Neutronics analysis of demonstration and experimental fast reactors with transport methods

Response on the report by Áron Brolly

Böröczki Zoltán István

Figure 1. Primary system of the ALFRED reactor.

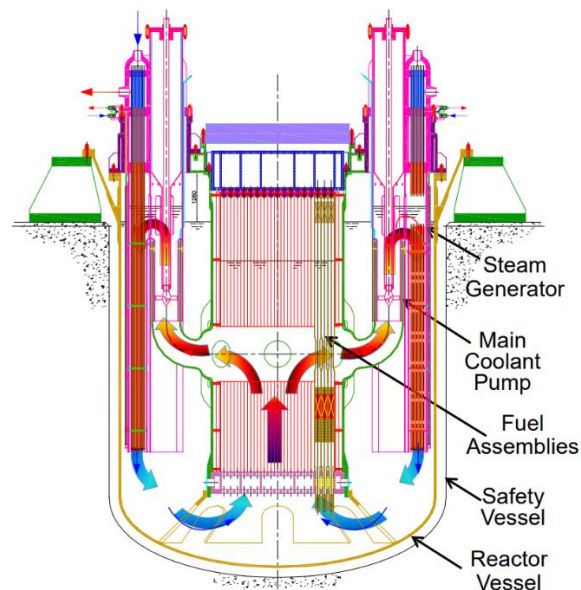
S7. In Figure 5.6, according to the legend, the reactor vessel is surrounded by lead, indeed?

The core specification of the ALFRED reactor mentions two reactor vessels. The legend in Figure 5.6 refers to the "inner vessel" in which the zone takes place, and in Figure 1, the "main vessel" is visible with the primary system. Figure 5.6 represents a schematic layout of the ALFRED reactor, mainly for neutronics modelling.

Figure 2. The effect of the higher-ordered expansion of the angular dependent flux in a curvilinear geometry.

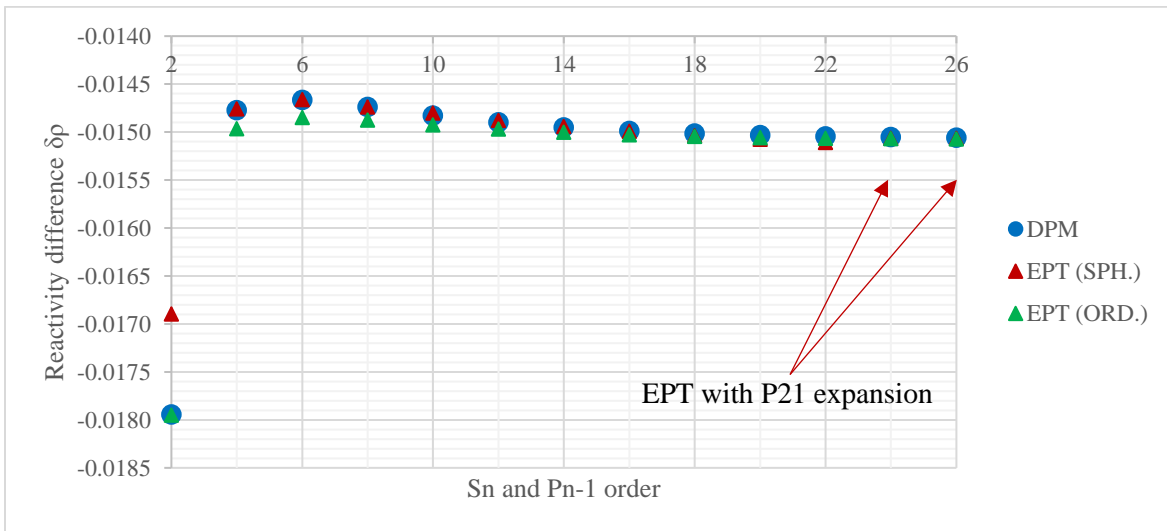
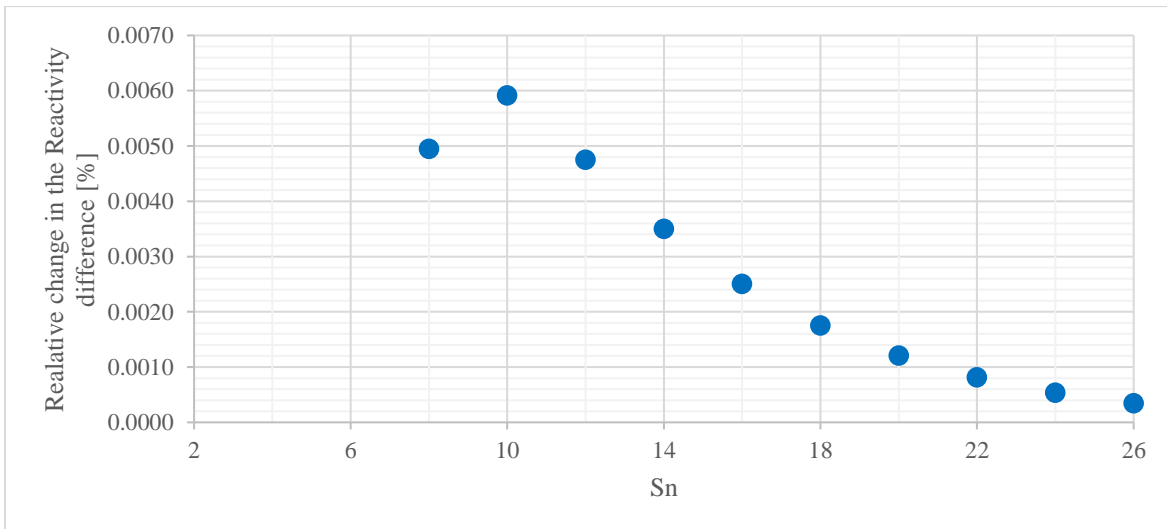
3. Question: To Figure 4.6 but rather to Figure 4.9. As the order of expansion increases the reactivity difference curve does not show stabilization, instead of it has a maximum. Taking this into account, which expansion does the candidate suggest using? In addition, what kind of effect could have a wrongly chosen expansion on the result of a nuclear safety analysis?

In Figure 4.9. (and probably in Figure 4.6.), the decreasing trend corresponds to the slowly converging reactivity effect due to the increasing angular expansion in the numerical model. It might not be so evident in the dissertation. However, if we perform this analysis in even higher angular discretizations, it converges to a fixed value, as can be seen in the following figures:

Figure 3. Convergence of the reactivity change

(Deviations start to arise at high angular expansion with the spherical harmonics (over P17). This is caused by the inaccurate estimation of the higher moments in the expansion from the given ordinate set. When S24

and S26 sets were used, the spherical harmonic expansion was set to P21, which corrected the coefficients resulting in a better agreement.)

There were no major differences between the results in Chapter 4, whether the spherical harmonic or the discrete ordinate representation was used. Therefore later, I mainly used the spherical harmonic representation as it was easier to implement the functions. I think a badly chosen set could affect the result in two ways:

1. The discrete ordinate set used in the deterministic calculation is not dense enough to accurately determine the flux solution; therefore, the flux will be inaccurate, which will highly affect the integration of the whole phase space.

2. Let's say we apply a dense enough ordinate set; then not necessary to expand the flux moment for a really high order as high momentum can affect the capture T1 and the scattering term T3. For the scattering, the spherical harmonic expansion to the 5th order should be sufficient, as I have not seen any scattering cross-section data going beyond that. Therefore the T1 term can depend on the higher moments; however, these examples did not have large angular anisotropies, which would require larger than L=5 expansion.
